PROJECT COMMENTS

PROJECT NUMBER: SP2022-045
PROJECT NAME: Site Plan for Alumni Bar & Grill
SITE ADDRESS/LOCATIONS: 906 S GOLIAD ST

CASE CAPTION: Discuss and consider a request by Allen Anderson of Adlor Enterprises, LLC for the approval of a Site Plan for a Restaurant on a 1.1308-acre parcel of land identified as Lot 1, Block B, Jack Canup Addition, City of Rockwall, Rockwall County, Texas, zoned Planned Development District 62 (PD-62) for General Retail (GR) District, addressed as 902 & 906 S. Goliad Street [SH-205], and take any action necessary.

SITE PLAN

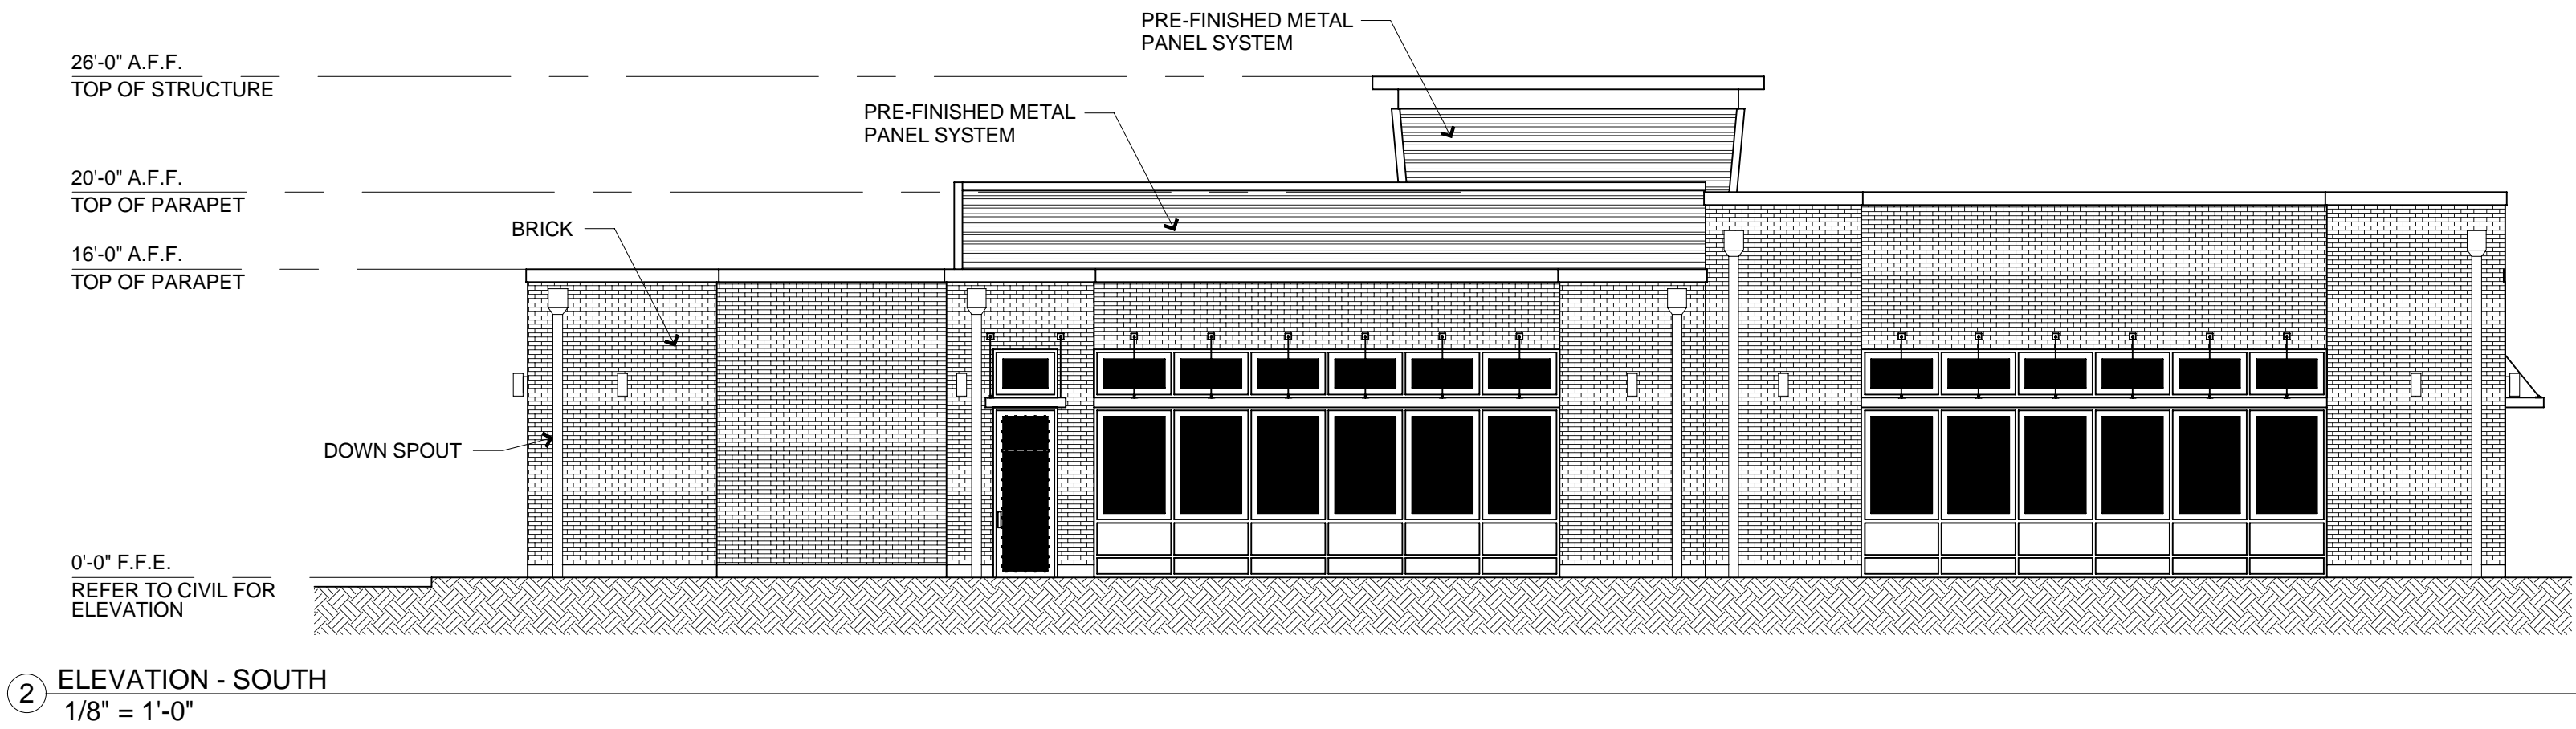
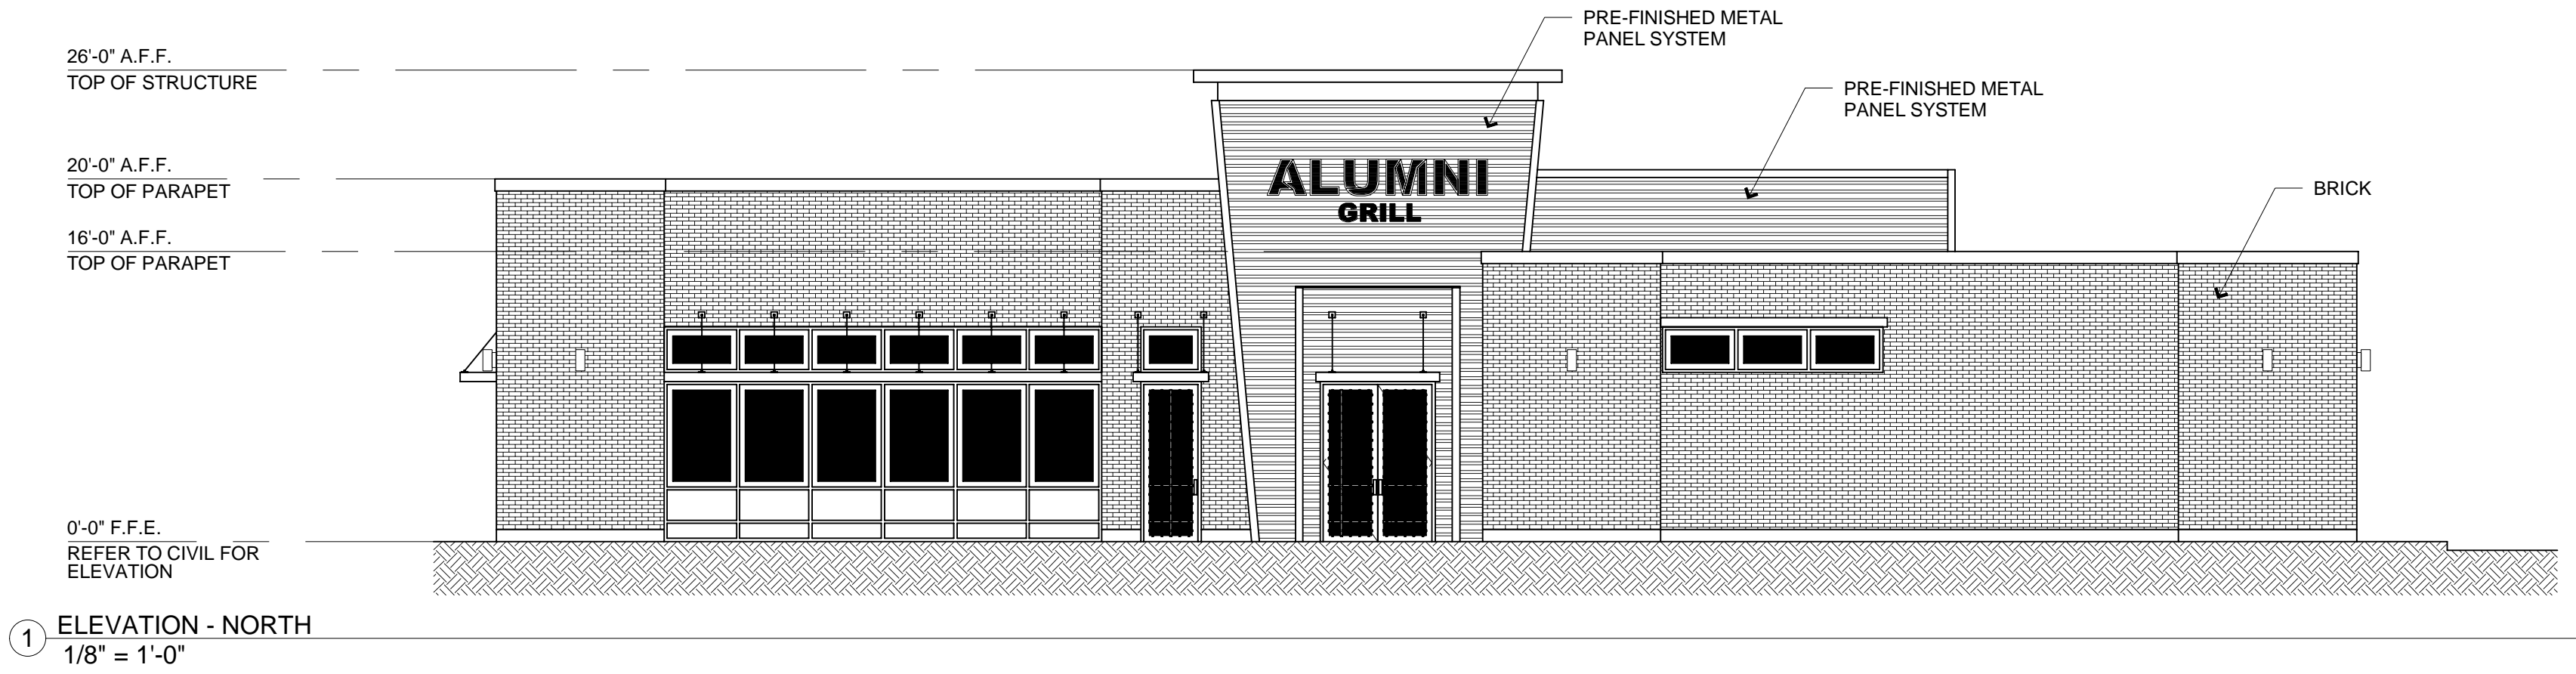
M.8 Site Plan:

1. Please provide the total lot area in acreage and square footage. (Subsection 03.04. B, of Article 11)
2. Please provide the perimeter dimensions of the site. (Subsection 03.04. B, of Article 11)

3. Please indicate the building setbacks. (Subsection 03.04. B, of Article 11)
4. Please label the drive radii and drive widths. For a building under 30-feet the radii must be 20-feet. The drive widths must be a minimum of 24-feet. (Subsection 03.04. B, of Article 11)

5. Please label the fire lanes as Fire Lane, Public Access, and Utility Easement. (Subsection 03.04. B, of Article 11)
6. The parking requirement is 1 per 100 square feet. In this case you need 50 parking spaces not including any patio seating, which is 1 space per 4 seats. Just considering the building you are short 4 spaces. To remedy this, without major site changes, the building could be reduced in size and/or a few spaces might be gained near the dumpster enclosure. (Table 5, Article 06)

7. Indicate the height of the proposed masonry screening wall. Also provide a wall detail that depicts the height, materials, and design. (Subsection 08.02. F, of Article 08)

8. Indicate any ground mounted utility equipment and the subsequent screening. (Subsection 01.05. C, of Article 05)
9. Indicate any roof mounted utility equipment and crosshatch it on the building elevations. (Subsection 01.05. C, of Article 05)

10. Dumpster Screening. Trash/Recycling enclosures shall be four (4) sided. These receptacles shall be screened by a minimum six (6) foot, solid masonry dumpster enclosure that utilizes the same masonry materials as the primary building and incorporates an opaque, self-latching gate. The minimum enclosure area shall be 12'x10'. A minimum of 6" bollards will be required at potential impact zones and the pad site shall be paved to city standards. 5-gallon evergreen shrubs must be planted around the enclosure. (Subsection 01.05. B, of Article 05)

- 08/25/2022: - Must show existing/proposed utilities.
- Sidewalk to be 2' from ROW/Property line.
 - 100' min required driveway variance needed.
 - Parking adjacent to the building to be 20x9' minimum.
 - Must have 15'x64' parking turnaround. Striped and signed "No Parking"

BUILDING
ELEVATIONS

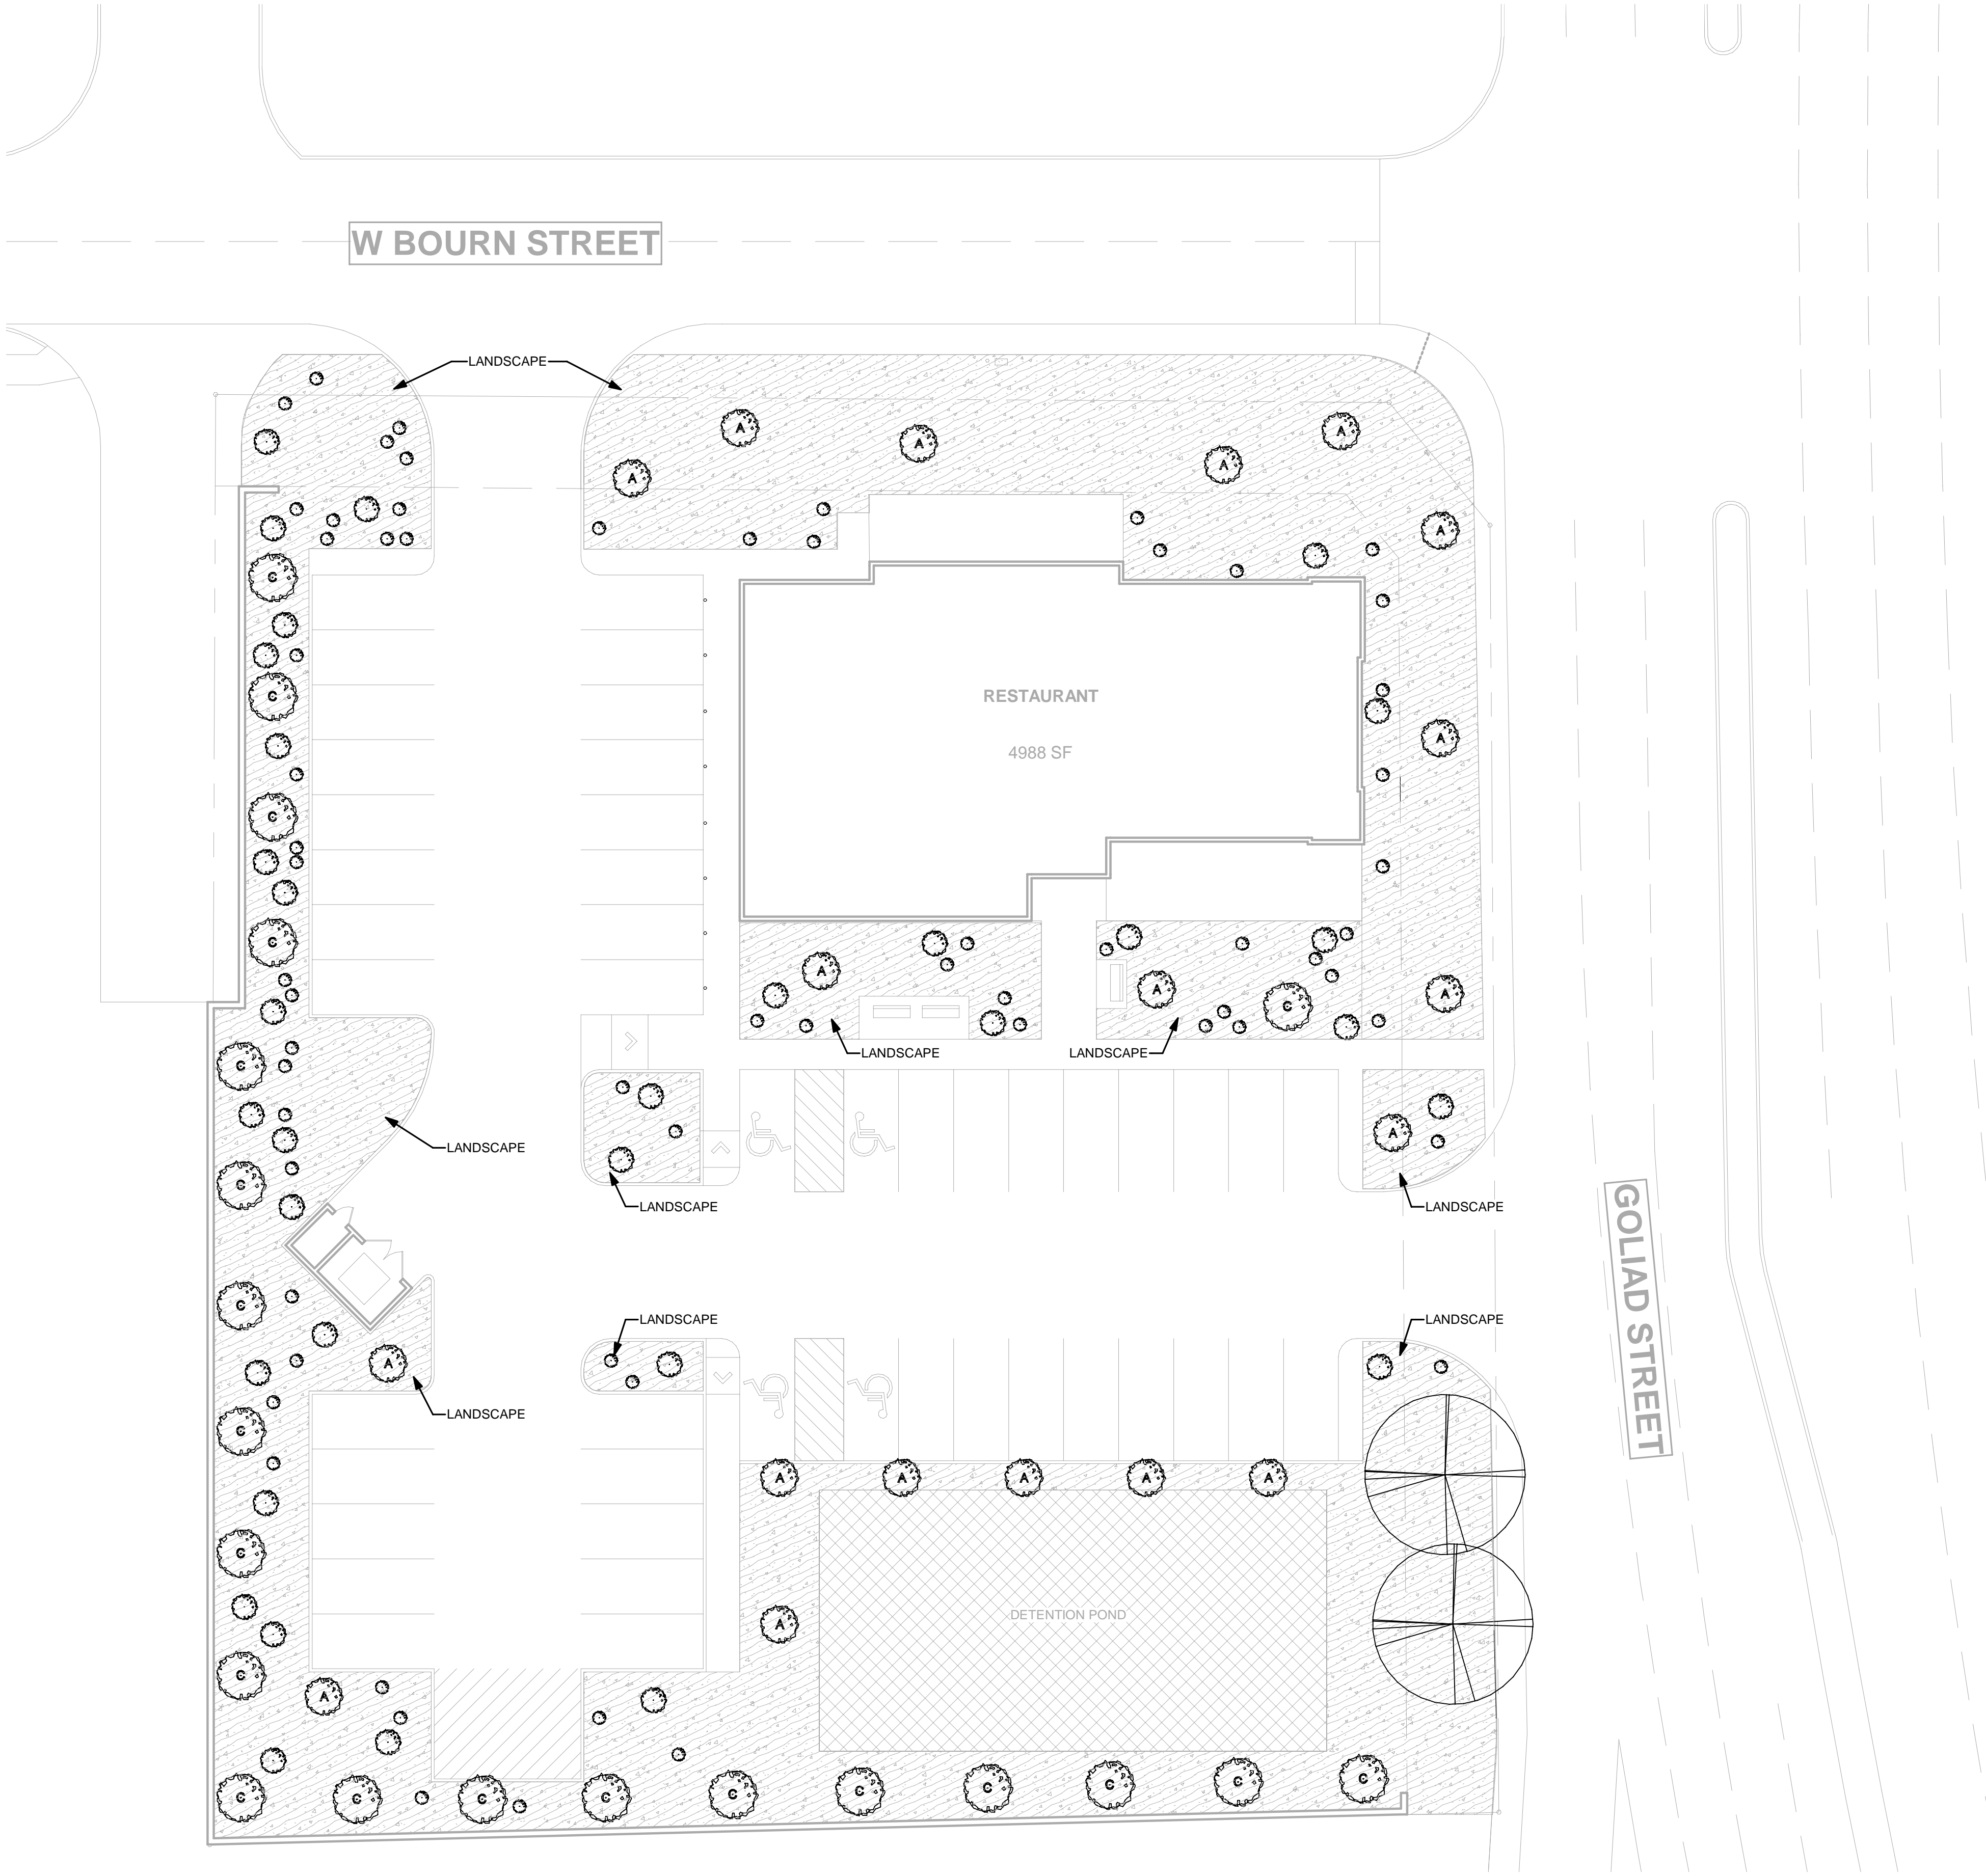
M.12 Building Elevations:

1. Please verify the orientation of the building; the directional callouts do not appear to be correct. (Subsection 06.02. C, of Article 05)
2. Please provide the material percentages on each façade of the proposed building. (Subsection 04.01, of Article 05)

3. Please be more specific on the building materials; specify the brick, concrete panels, and metal panel system. (Subsection 04.01, of Article 05)
4. Please provide a note indicating that the parapet will be finished on both sides with the same material as the exterior facing wall. (Subsection 04.01, of Article 05)
5. The wall on the west side of the building does not meet the wall length requirements. Either a wall projection going 2.5-feet out can be added or a variance can be requested for the secondary façade articulation. (Subsection 04.01.
6. Please crosshatch the roof mounted utility equipment. (Subsection 01.05. C, of Article 05)
